REGIONAL REVIEW FINDING

ARC REVIEW CODE: R504061

Submitting Local Government: Gwinnett County
Name of Proposal: Brogdon Road Industrial Site

| Preliminary Report: | April 6, 2005 | DEVELOPMENT OF REGIONAL IMPACT REVIEW REPORT | Project: | Brogdon Rd Mixed Use Dev # 759 |

CONCEPT PLAN
for
Brogdon Road Industrial Park DRI

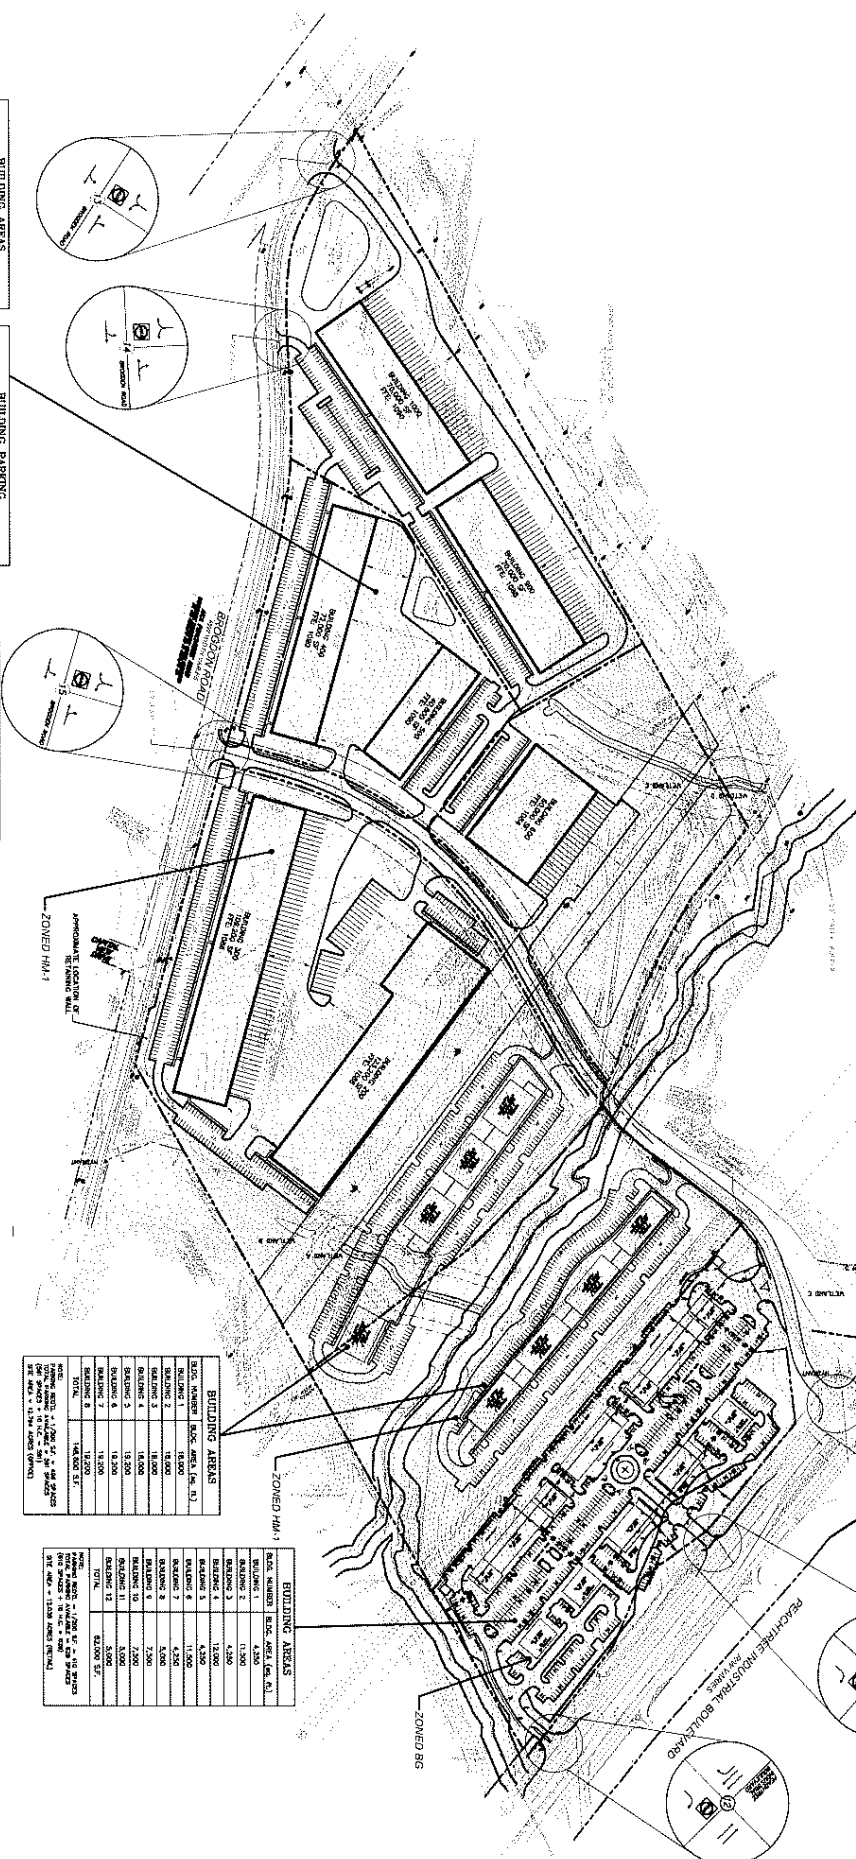
The development proposed retail and office uses along Peachtree Industrial Boulevard. Significant residential development has taken place and is planned on the other side of Peachtree Industrial Boulevard. The office and retail will be well placed to serve those residents. Refinement of the site plan could minimize the emphasis on the parking. Reorienting the buildings around a plaza and placing the parking in the back with vegetative screening will create a more pedestrian friendly atmosphere throughout the retail area. Pedestrian connections, that include alternatives to sidewalks, should be provided between the office and retail components of the project.

The site plan illustrates shared parking truck pads, vehicle connectivity between the buildings, and shared driveways for the warehouse distribution portion of the site. It is recommended that as the site

The Suwanee ordinance requires a 50-foot undisturbed buffer and an additional 25-foot impervious surface setback on most streams including Brushy Creek. The site plan shows a 35-foot buffer along Brushy Creek. A 10-foot buffer is shown on a tributary to Brushy Creek in the western portion of the property. The proposed project needs to meet City requirements and the plans need show the required City buffers on all applicable streams on the property.

- Only one stormwater quality structural control (BMP) is identified on the site plan (first flush basin). Ensure that adequate stormwater facilities are provided to treat site stormwater runoff from the entire site as well as for detention storage for downstream channel protection and the 25-year storm event (peak flow attenuation) per guidelines in the Georgia Stormwater Management Manual. Detention ponds should be designed as multi-purpose (water quality and detention) facilities wherever possible and incorporated into the sign design as amenities.

- Site design should be modified if possible to better fit the contours of the terrain and preserve more undisturbed green space. This will reduce the hydrologic impact of the site as well as reduce clearing and grading and stormwater infrastructure costs.
